Marked up claims and specification for response to the office action mailed on April 23, 2002.

Serial No. 09/772,177

For WEB TRACKING ADJUSTMENT DEVICE AND METHOD THROUGH USE OF A BIASED GIMBAL

Marked up drawings for response to the office action mailed on April 23, 2002.

FIG-3

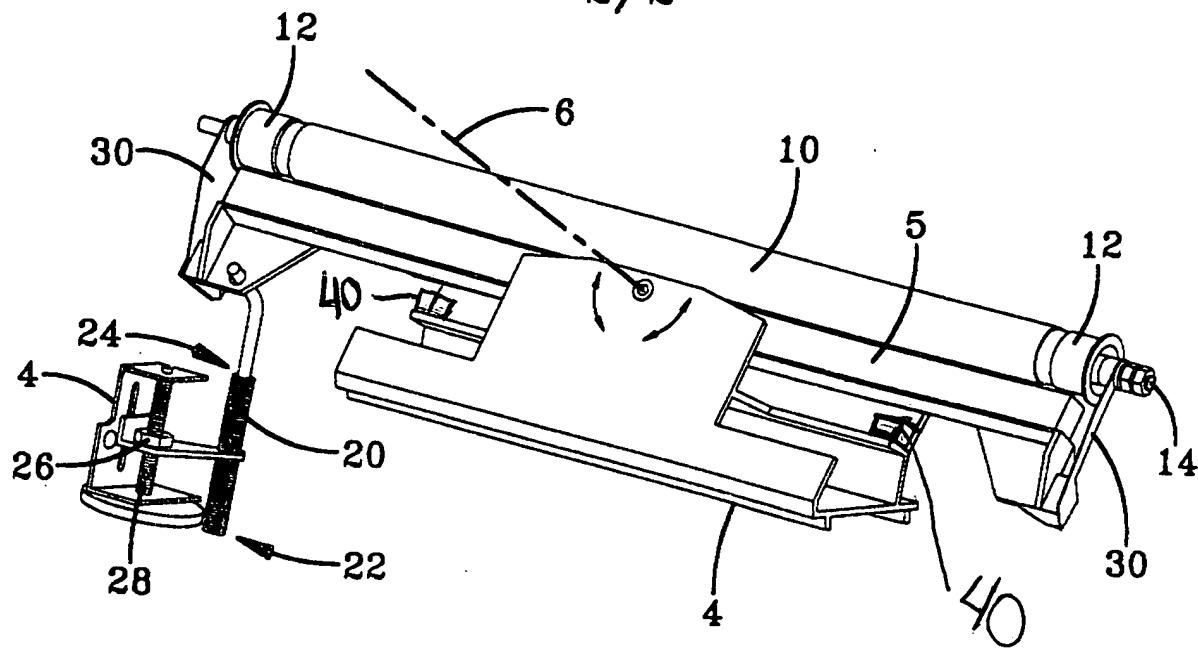
The drawings are objected to under 37 CFR 1.83(a), as the drawings must show every feature of the invention specified in the claims. Examiner states that the stopping means (see claim 16) must be shown, or the feature cancelled from the claims. The drawings are amended herein to include a stop **40**. Applicants respectfully submit that as amended the drawings are in more proper form, in compliance with the examiner's request.

According to a further aspect of the invention, a stop 40 is used for preventing the steering roller 10 from rotating too far in the gimbal direction.

FIG-4

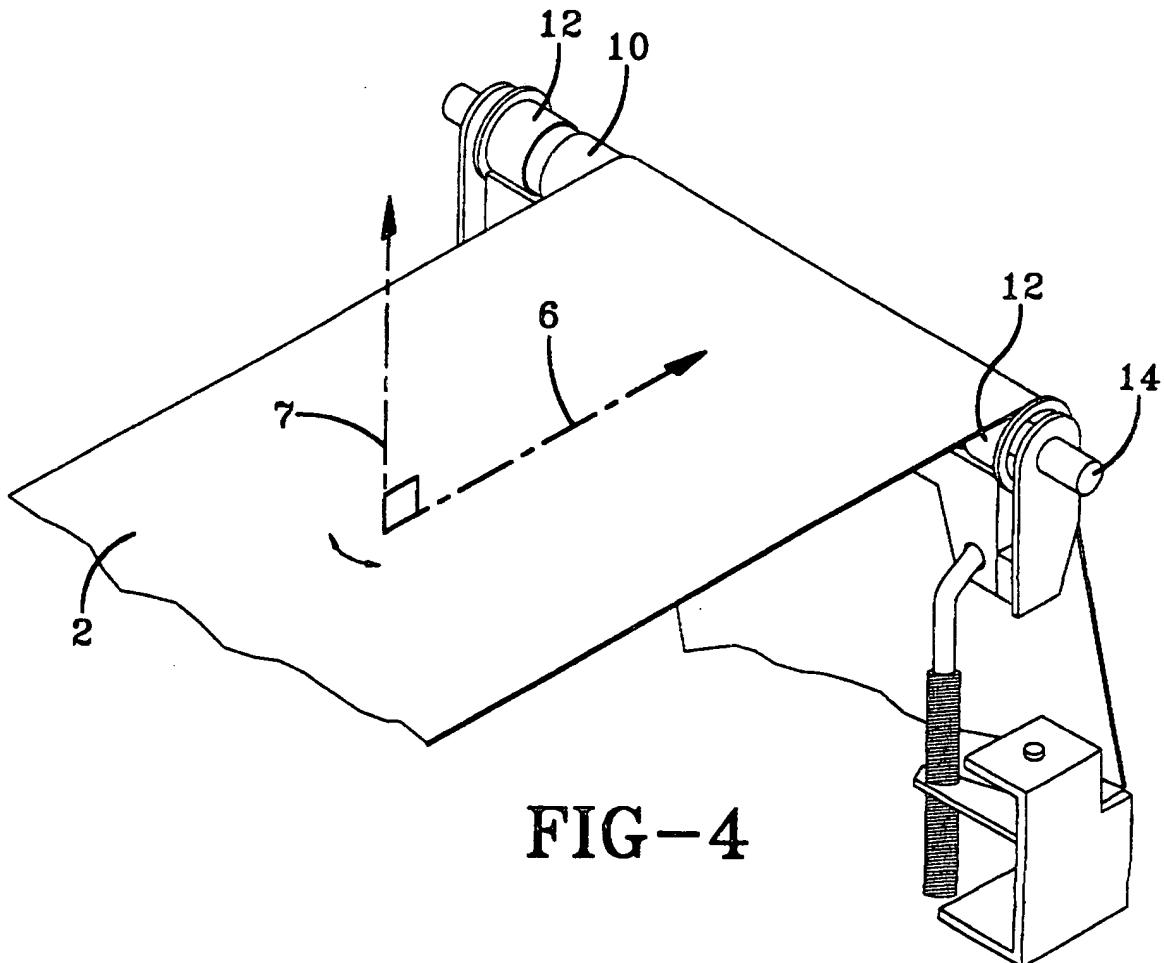
Regarding claims 7, 8, 10, and 20, the Examiner asks “what is a caster axis?” Referring to the specification page 3 lines 23-25 “a caster axis 7, which is

an axis perpendicular to the gimbal axis, which intersects the gimbal axis 6 upstream of the roller." Further, Figure 4 shows a caster axis 7. For the purposes of examination, the examiner has assumed that "the caster axis is perpendicular to the gimbal axis." Reference to the specification shows that the caster axis is indeed perpendicular to the gimbal axis, AND it intersects the gimbal axis upstream of the roller. Applicants respectfully submit that rejection of claims 7, 8, 10, and 20, and the claims which depend from them, on this basis is in error, and request that the rejection on this basis be withdrawn.
